Brake Activation Wire in Wrong Location <u>Description</u>

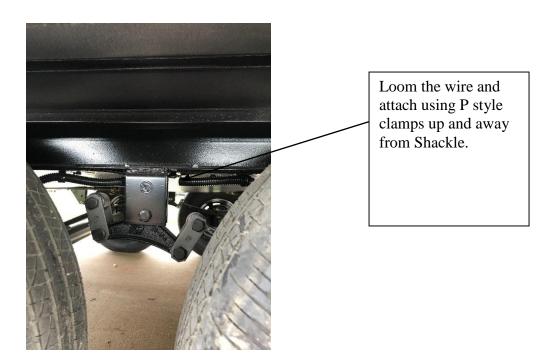
On certain Prowler & Trail Runner travel trailers, the electric brake wiring may have been routed too close to the center spring hanger of the axles. This could cause the wiring to catch or chafe against the spring hanger, and sever the wire. If the brake wire were to be severed for one of the axles, braking would be lost on that axle, which would increase stopping distances, and increase the risk of a crash causing injury and/or damage to property. The correction will be to relocate and clamp the wires out of the travel of the spring hanger and shackle.

1. Wires in wrong location: if your trailer has the wiring routed here next to the center axle hanger, the wires are in the wrong location. If they are not routed here but rather above the axle the trailer needs <u>no</u> repair. – file claim for inspection only.

- 2. Attach loom over wire from the top of the axle to the underbelly, and tape off ends with electrical tape.
- 3. Install P bracket over wire and attach to frame.
- a) Be sure that wiring and bracket cannot be hit if shackle contacts frame.
- b) Be sure to remove all slack from wire.
